POOR AUDIO SYSTEM RECEPTION OR WHISTLING-TYPE NOISE ON AM OR AM-HD BANDS ONLY - BUILT ON OR BEFORE 11/30/2013	TSB 15-0119
--	--------------------

2013-2014 Flex

This article supersedes TSB 14-0051 to update the Service Procedure, Parts List and Service Labor Time Standards.

Figure 1 - Article 15-0119

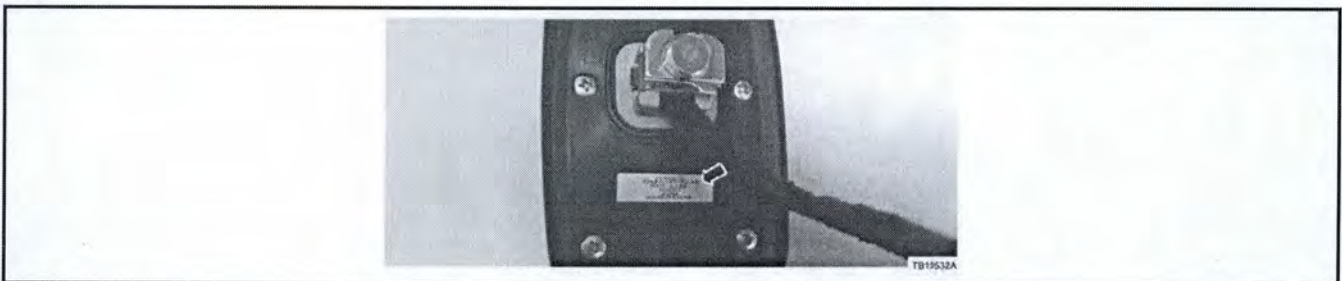
1. Does the audio system exhibit reception concerns or abnormal noises on FM band and/or satellite radio channels?
 - a. Yes - this procedure does not apply. Refer to Workshop Manual (WSM), Section 415-00 for normal diagnosis.
 - b. No - proceed to Step 2.
2. Is the vehicle built on or after 3/02/2013?
 - a. Yes - proceed to Step 5.
 - b. No - remove the antenna base. Refer to WSM, Section 415-00.
3. Inspect the antenna base part number located on the underside of the part.
4. Is the part number either DA8T-19G461-AC or DA8T-19G461-AD? (Figure 1)

- a. Yes - install the original antenna base. Proceed to Step 5.
- b. No - replace the antenna base with revised service part. Refer to WSM, Section 415-00. Proceed to step 5.
 - (1) Make sure the new ground clip, provided in the antenna part kit, is secured as shown in WSM 415-00.
5. Replace both the front and rear antenna cables. Refer to WSM, Section 415-00.
 - a. Cut circuit VME43 approximately 5 cm (2") from the male side of connector C212.
 - b. On the replacement rear antenna cable kit, cut the exposed pin off the blue power wire.
 - c. Splice the rear antenna cable blue power wire, from the replacement antenna cable kit, to the 5 cm (2") portion of circuit VME43, on connector C212. Use wire kit and recommended solder splicing method located in Wiring Diagram, Section 5.
